Subject: TIB 43-054: T800/T880 Improved Vertical Exhaust Heat Shields

**2017 Vertical Exhaust Heat Shield Replacement**

**43-054**

T800/T880 Vertical Exhaust Heat Shields

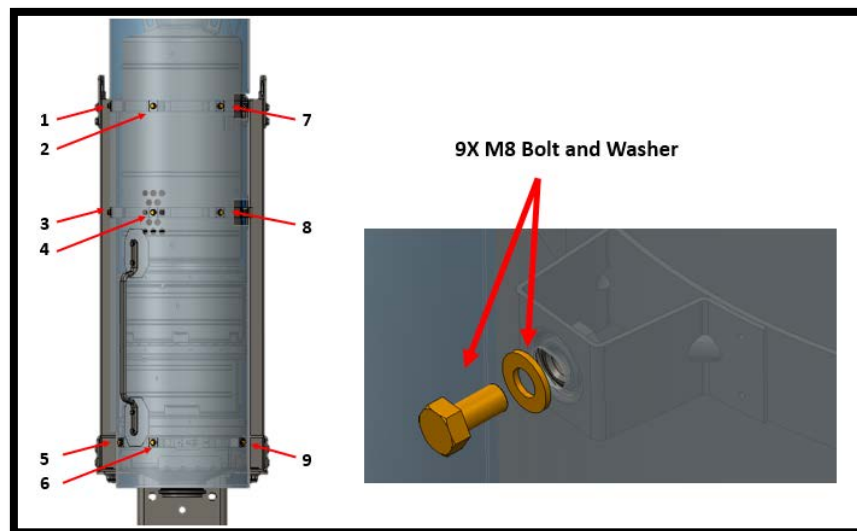
Divisions Impacted: Kenworth and Peterbilt  
Exhaust Assembly Impacted: M37-6252-000000

The original heatshields have an unsupported section that causes an audible rattling along with visual movement.

1. Remove the (9) M8 X 1.25 bolts and (9) M8 washers. They will be used for the new heat shield installation.
  - Bolt Part Numbers: 27-01260-016.
  - Washer Part Numbers: 27-00801-005P.
2. Remove the factory-installed heat shield and replace it with a new heat shield.
  - Factory-Installed Heat Shield: M46-6419.
  - New Heat Shield: M46-6440.
3. If grab handles are present, see the Grab Handle section below.
4. Install the new heat shield (M46-6440) with M8 X 1.25 bolts and washers removed during step 1.

## 2017 Vertical Exhaust Heat Shield Replacement

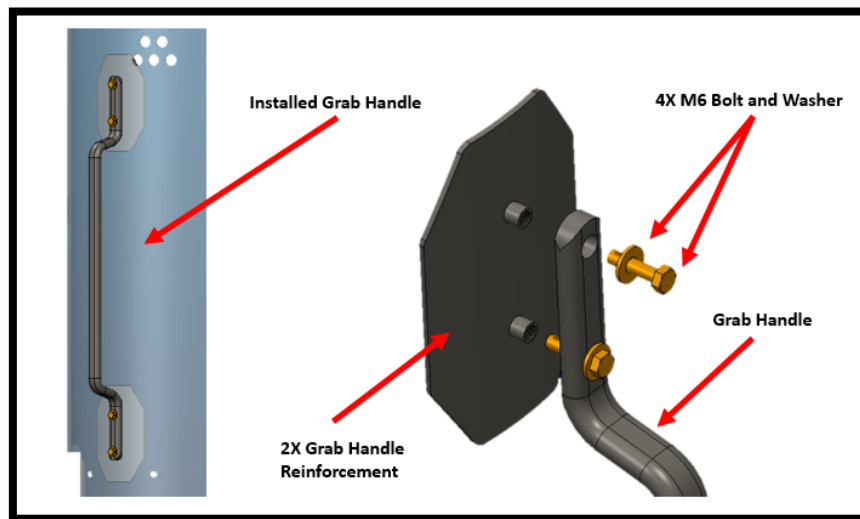
### Grab Handles

1. Remove the factory-installed heat shield.
2. Remove the (4) M6 bolts and (4) M6 washers. They will be used for installation on new heat shield.
  - Bolt Part Numbers: K041-813-16POL.
  - Washer Part Numbers: 27-00801-004P.
3. Remove the (1) grab handle and (2) grab handle reinforcements.
  - Grab Handle Part Number: K294-225
  - Grab Handle Reinforcement Part Number: M77-6001
4. Attach the grab handle and grab handle reinforcements to the new heat shield with bolts and washers from step 2.
5. Install new heat shield as noted in step 3 of heat shield replacement section.
